**City of Ramsey**  
**Agenda**  
**Regular Planning Commission**  
**Thursday, August 22, 2024**

Approve the Planning Commission Meeting Minutes for July 25th, 2024

Staff has attached the Changemark Report, dated August 14, 2024. Revised plans have been submitted, but a second round of plan review has not been completed yet (based on when the revised plans were received). While it may appear there are a number of unresolved comments, it is likely that many, if not all, comments have been addressed. Staff will try and give a verbal update on the status of the revised plans during the meeting.

**C1.1**  
 Overall Layout & Site Plan

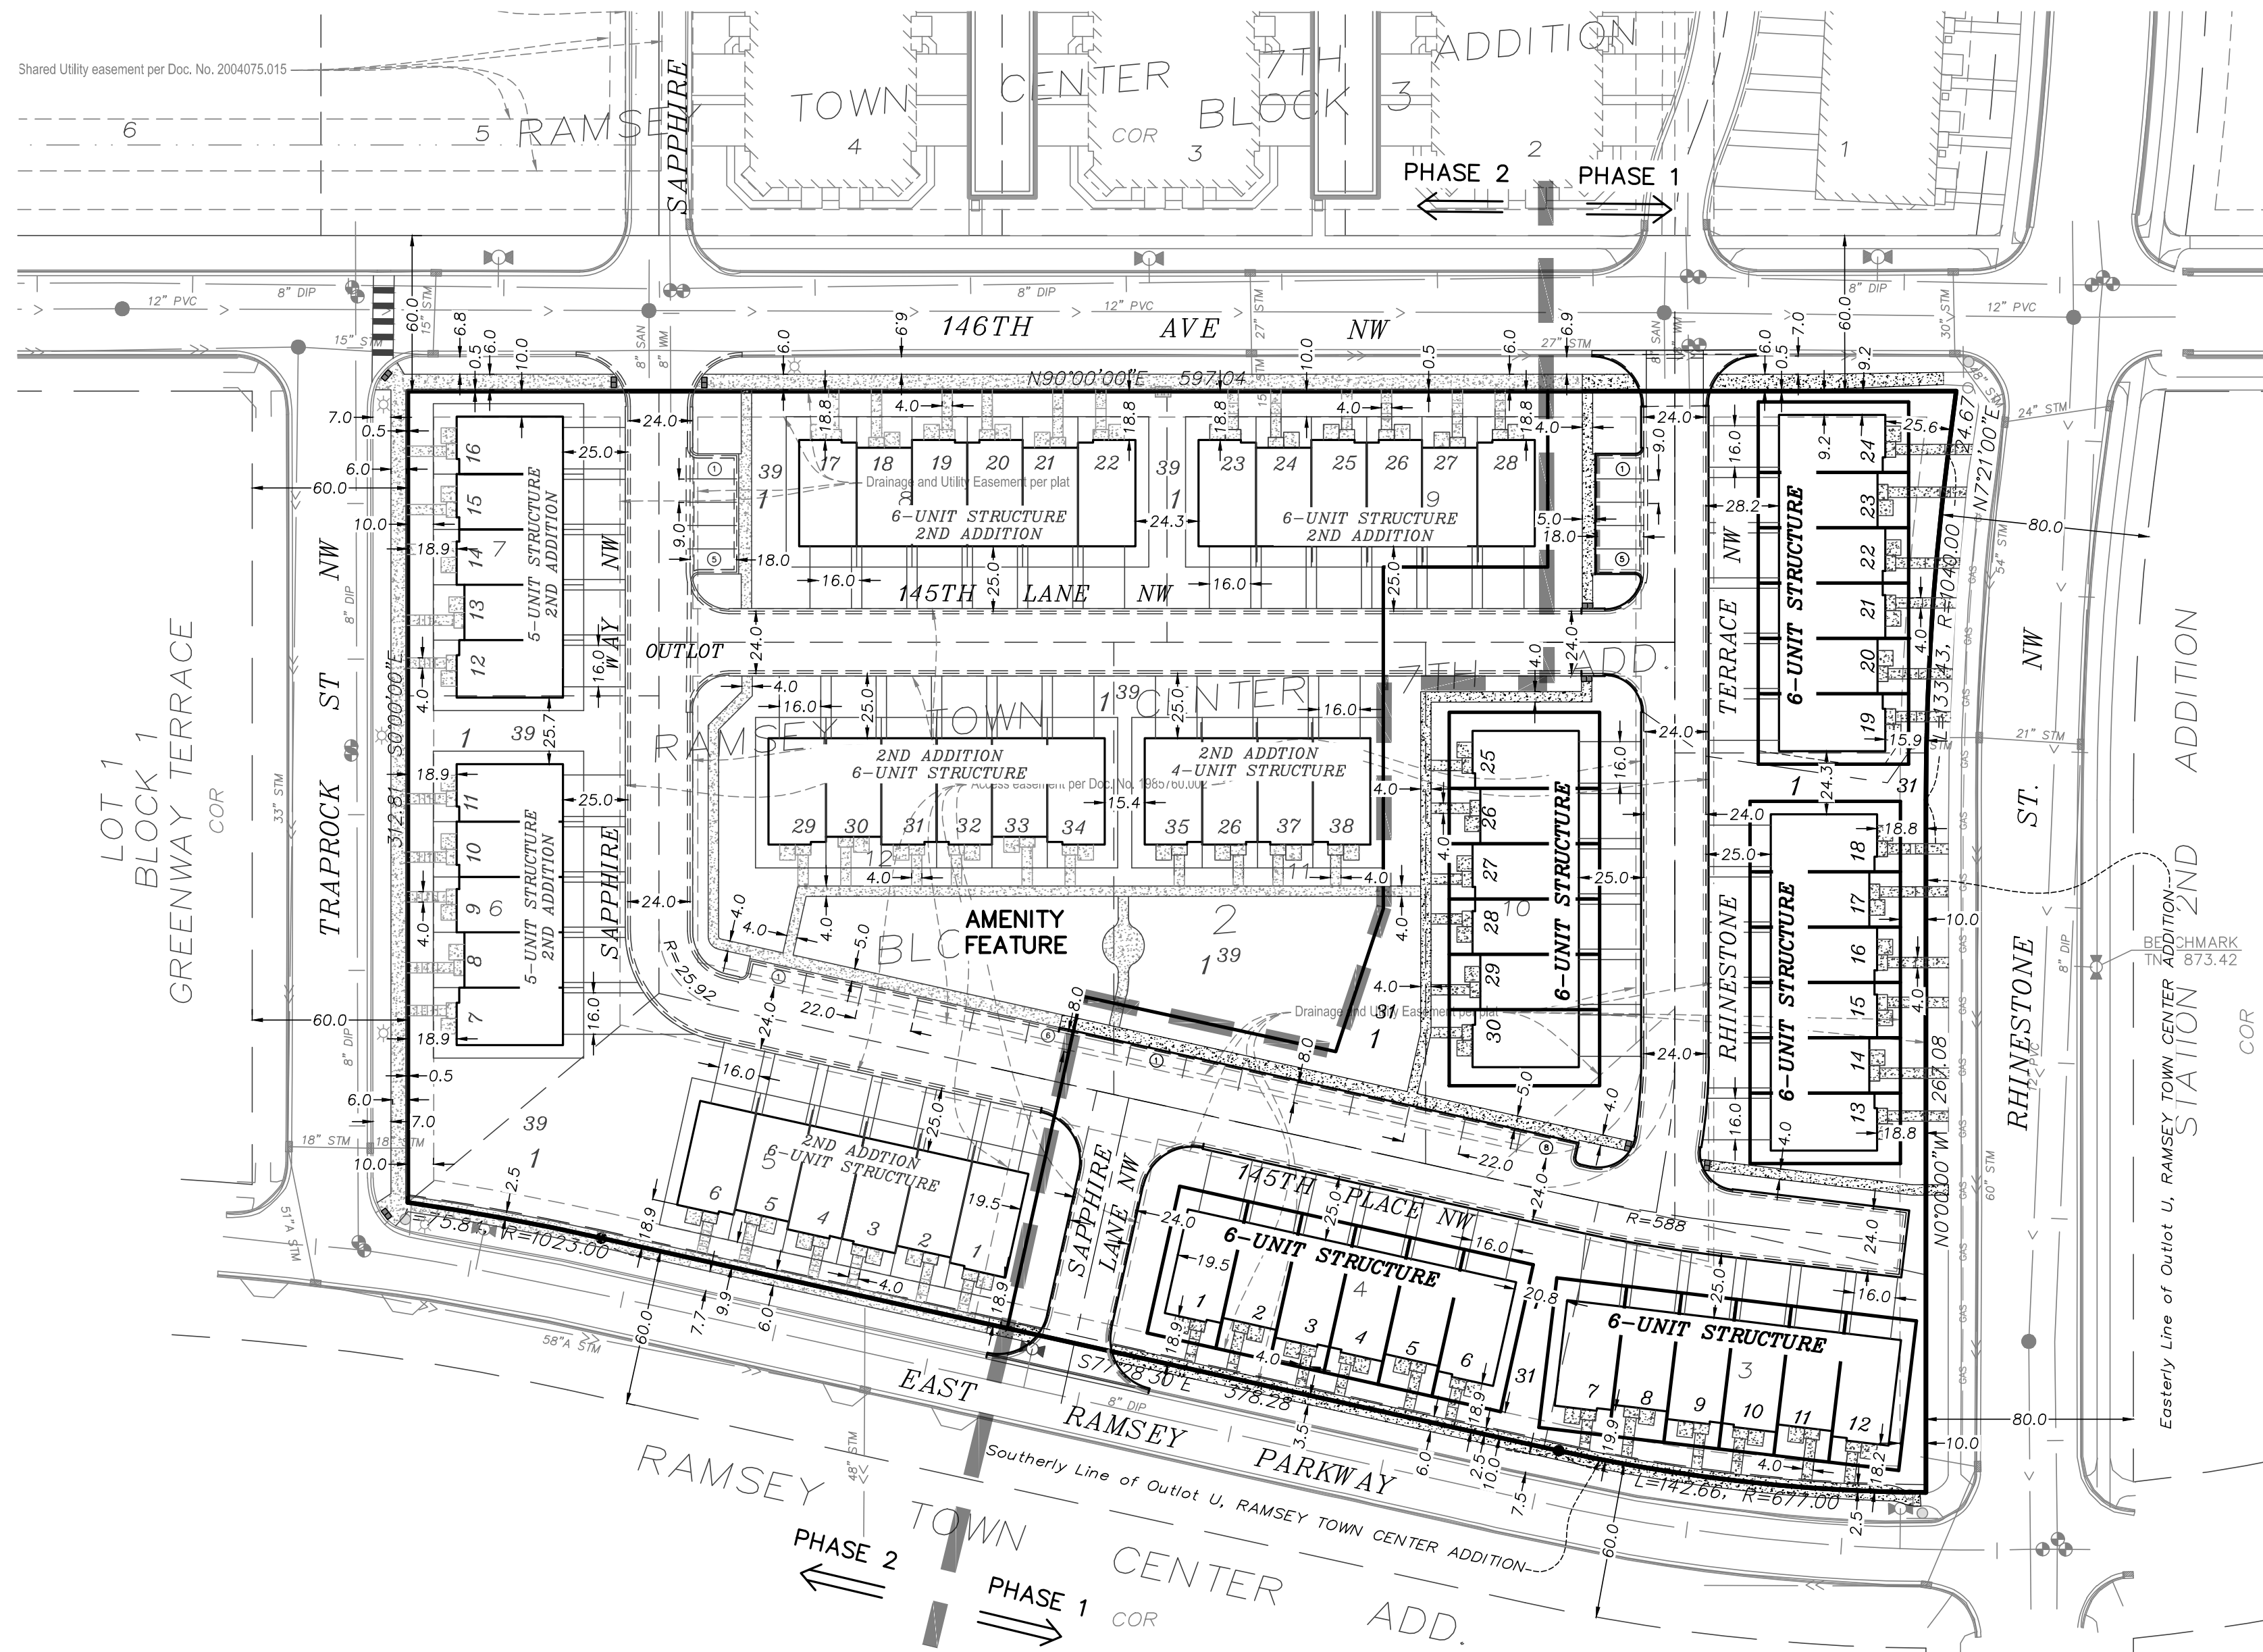
14	True	Resolved	City Planner		Civil C1.1 Overall Layout.pdf	CA	Street Light Locations	Why are these 2 street lights behind the sidewalk instead of in the boulevard?	07/23/2024 12:05 PM	Chris Anderson	Street lights moved to front of sidewalk.
		12	True	Resolved	City Planner		Parkside Townhomes Sidewalk Easement Exhibit.pdf	CA	Update Easement Exhibit	The Preliminary Plat indicates that building 5 will now be part of the 2nd Addition. This exhibit should be updated to reflect the new alignment of Outlot A.  Also, the Pre Plat now appears to identify the open space as Lot 31, not 43, this needs to be updated also.	07/23/2024 12:12 PM	Chris Anderson	Exhibit graphic updated accordingly.

Sheet Title: **Exterior Elevations**

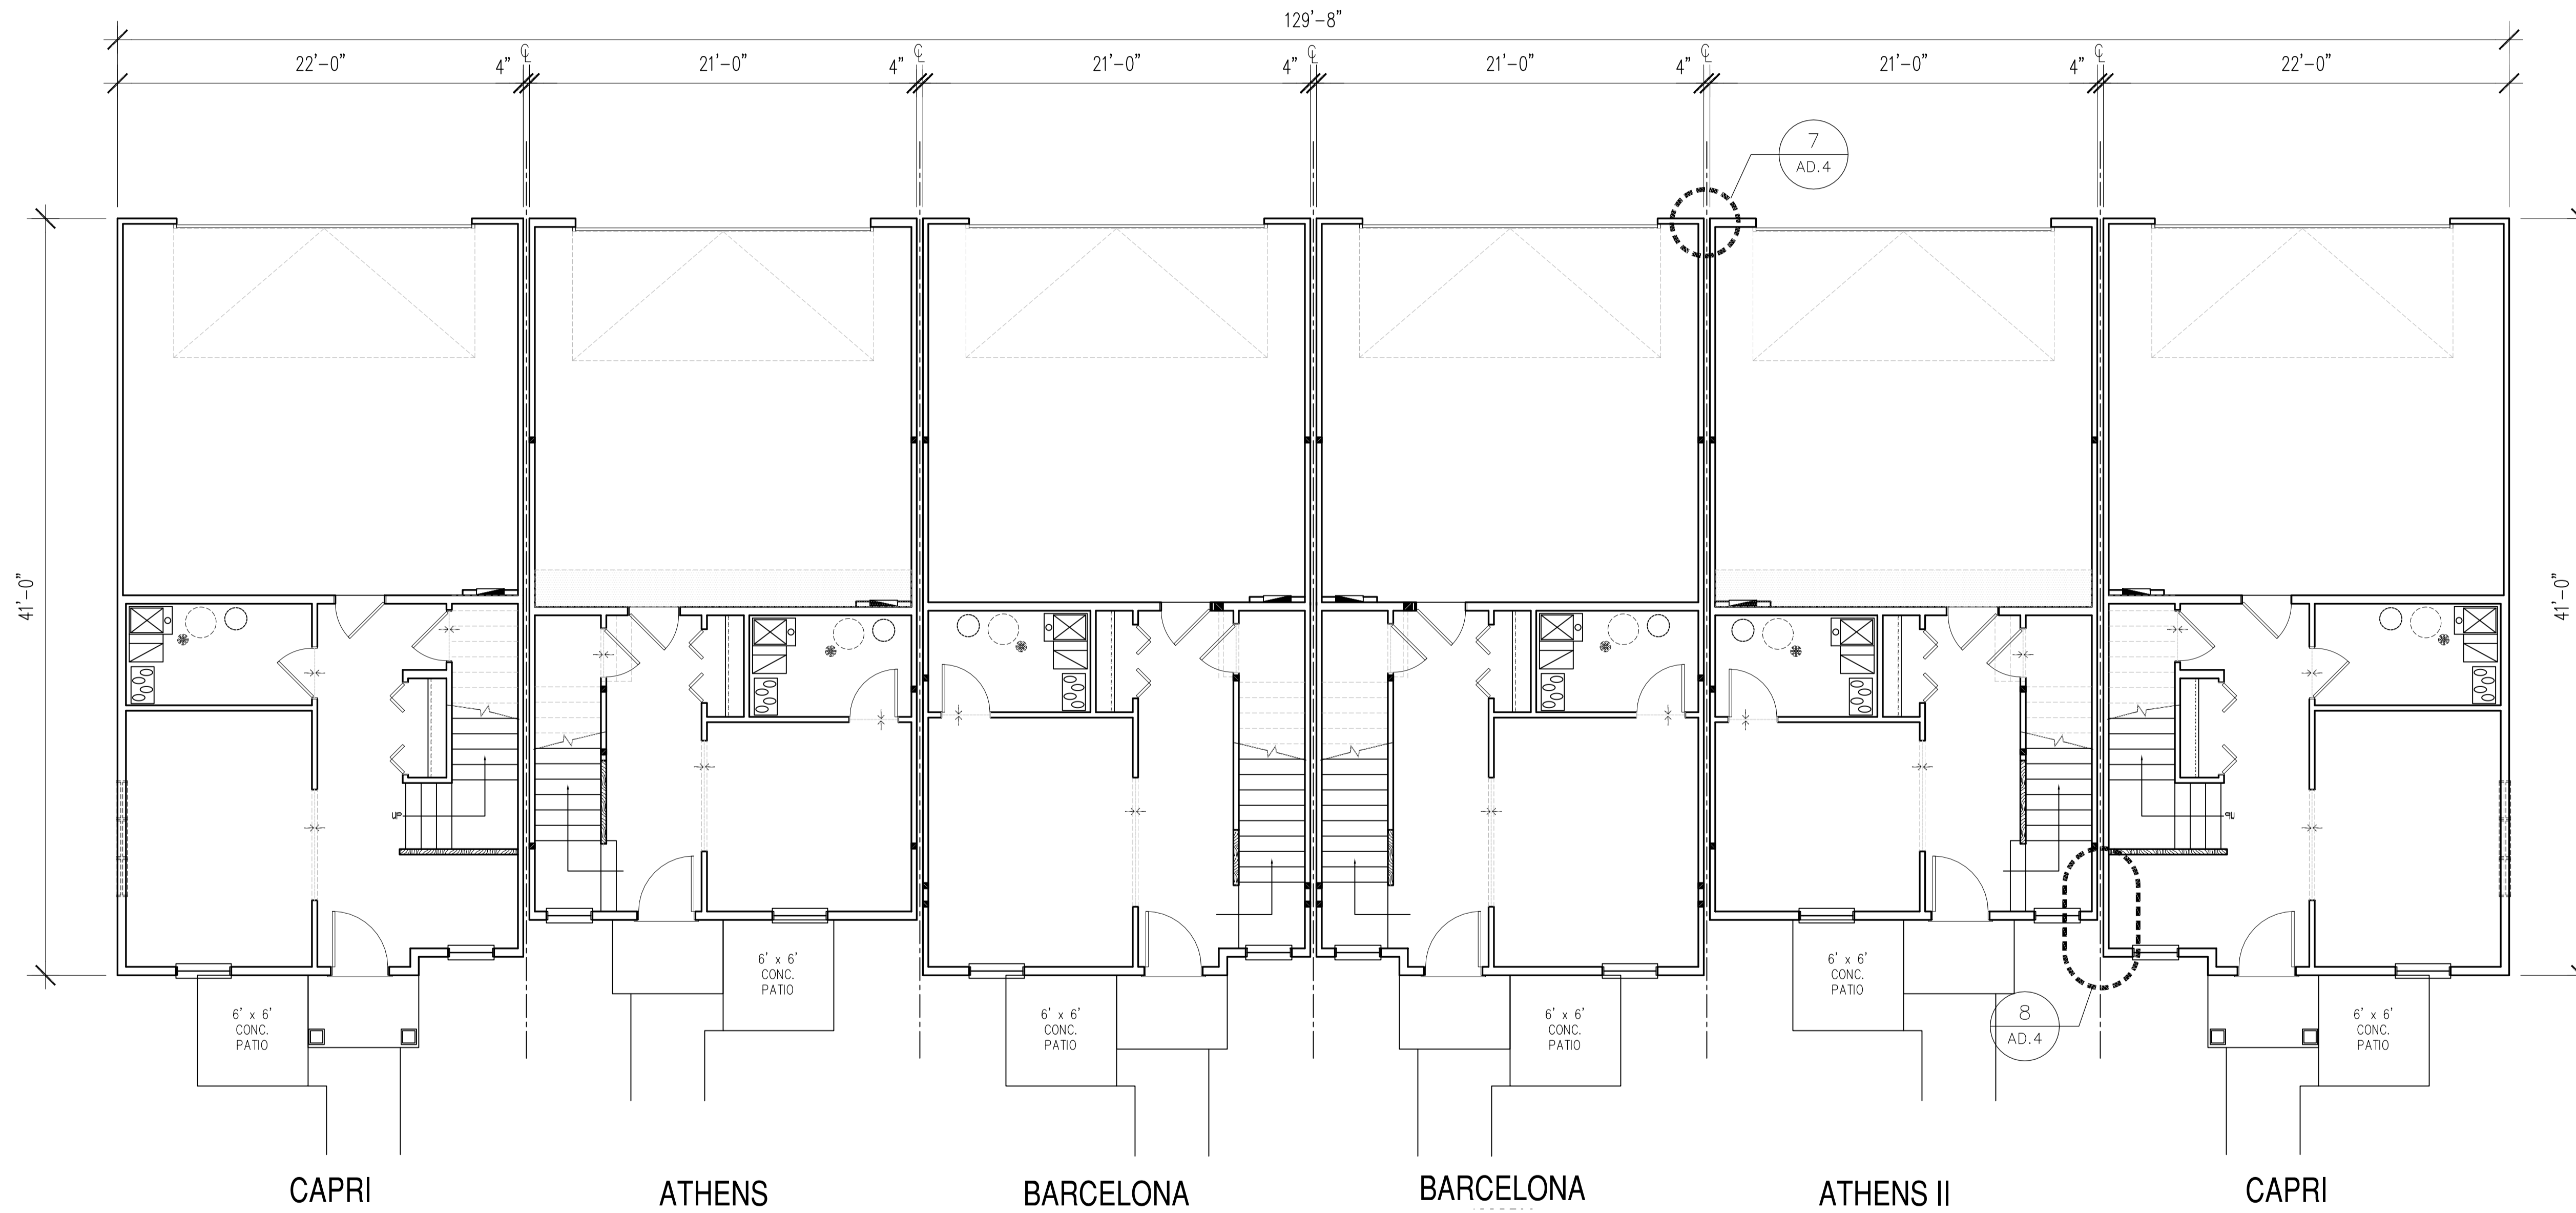
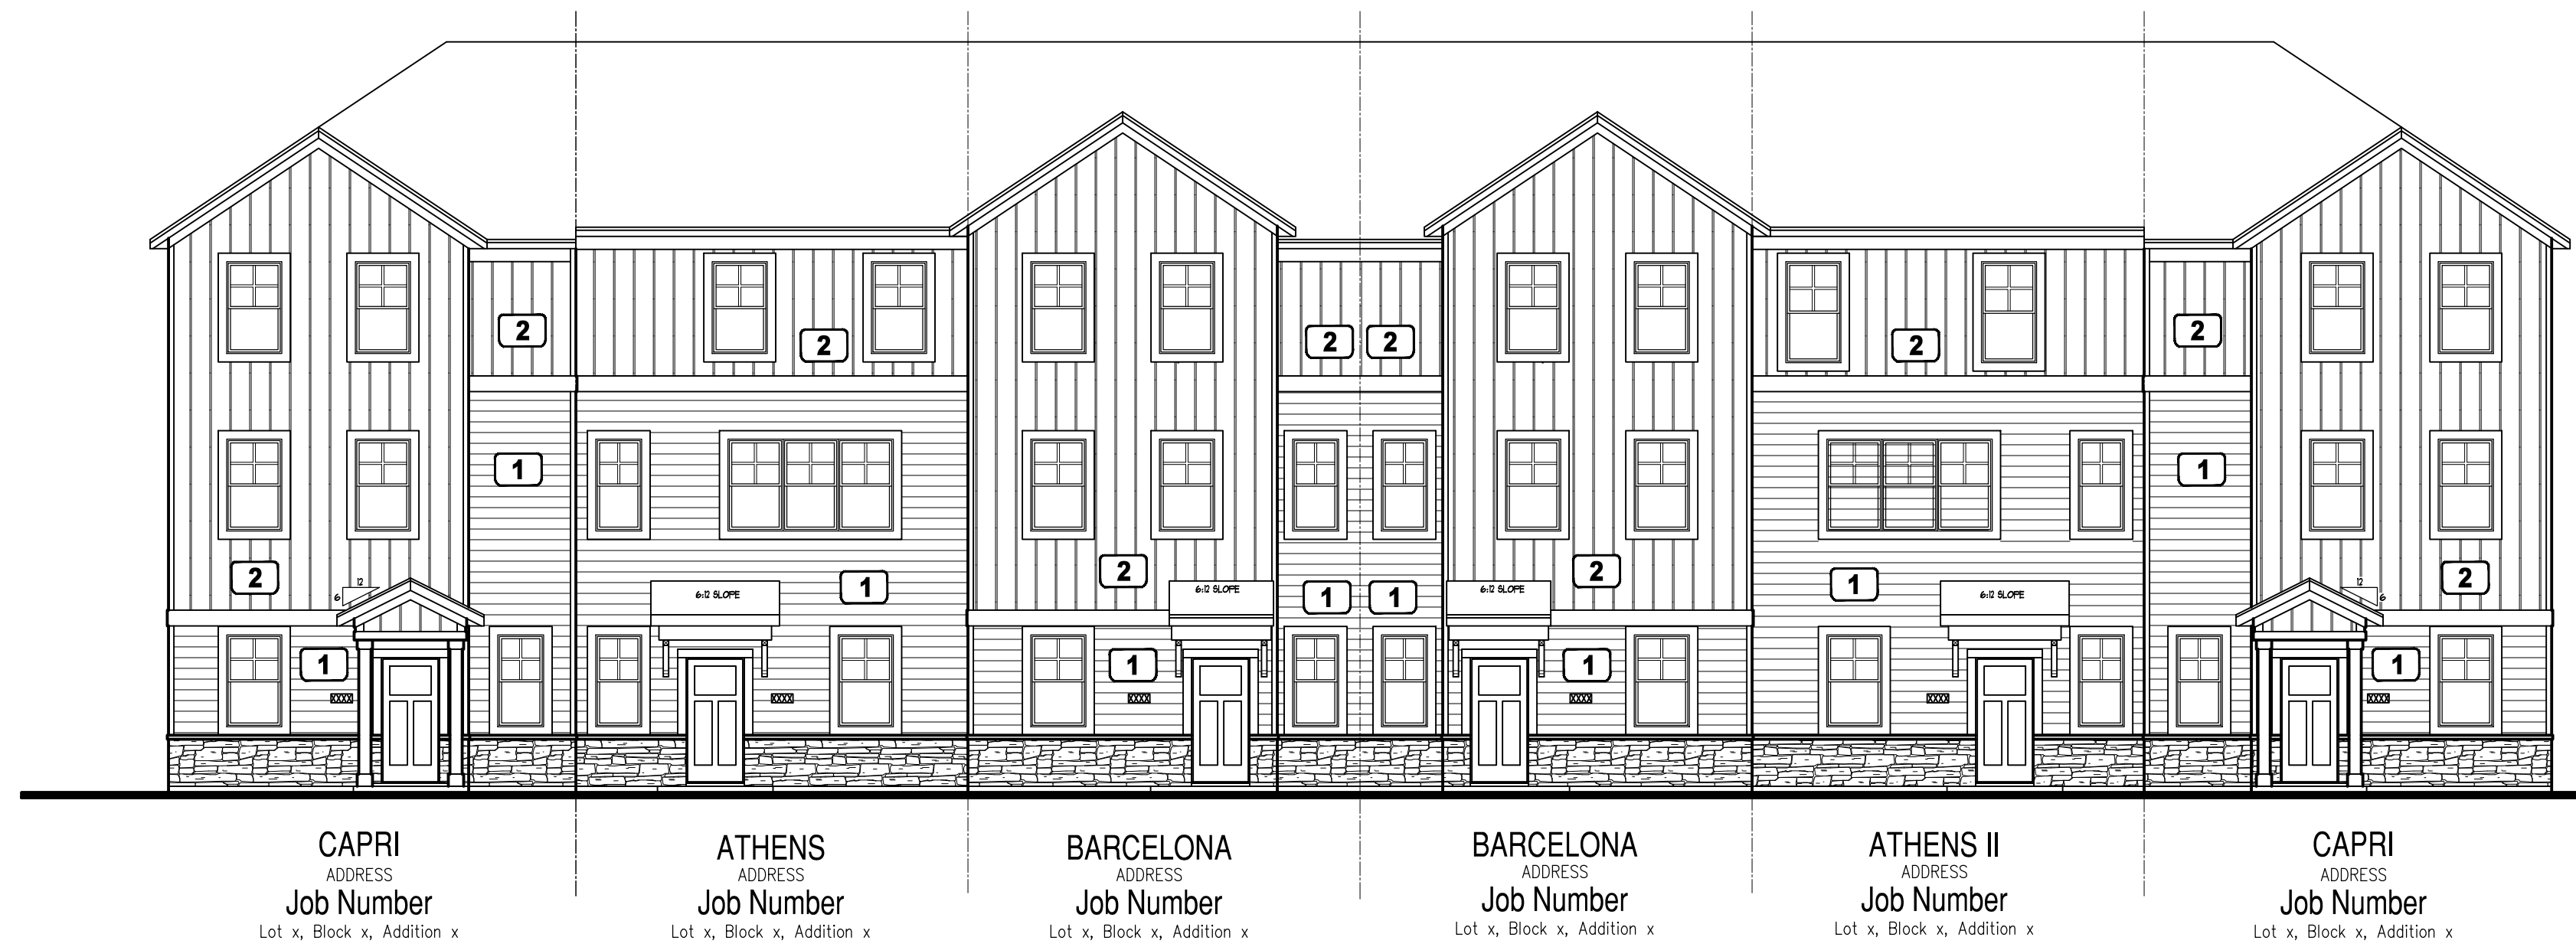
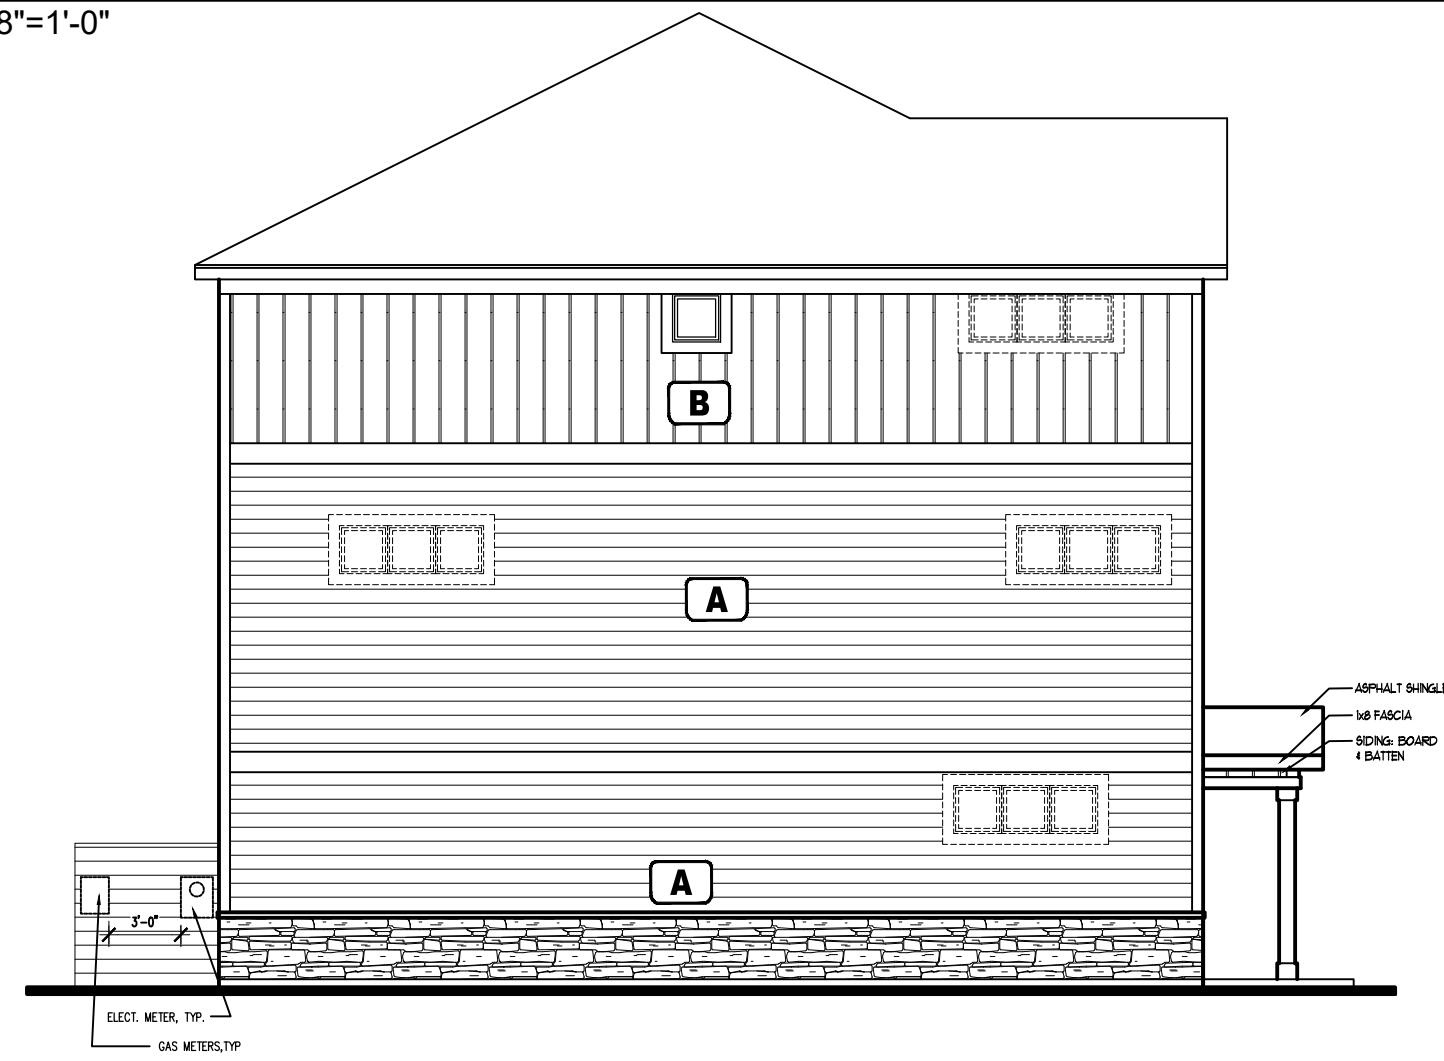
Grouping	Cycle	Ref #	Complete?	Status	Department	Snapshot	File	Markup Name	Changemark Subject	Changemark Details	Markup Date	Updated By	Applicant Response
Main Workflow	1	5	True	Resolved	City Planner		Architect Elev AAS1.pdf	CA	Patio	Need to add back in a patio, that is 'connected' to the front entryway, similar to what was ultimately supported by Planning Commission and City Council in 2023. This modification shall be reflected on all color renderings and the Building Elevations sheet.	07/23/2024 9:26 AM	Chris Anderson	An updated architectural rendering has been provided indicating patios will be provided consistent with previous approvals.
		4	True	Resolved	City Planner		Architect Elev 1 color.pdf	CA	Patio	Need to add back in a patio, that is 'connected' to the front entryway, similar to what was ultimately supported by Planning Commission and City Council in 2023. This modification shall be reflected on all color renderings and the Building Elevations sheet.	07/23/2024 9:24 AM	Chris Anderson	An updated architectural rendering has been provided indicating patios will be provided consistent with previous approvals.
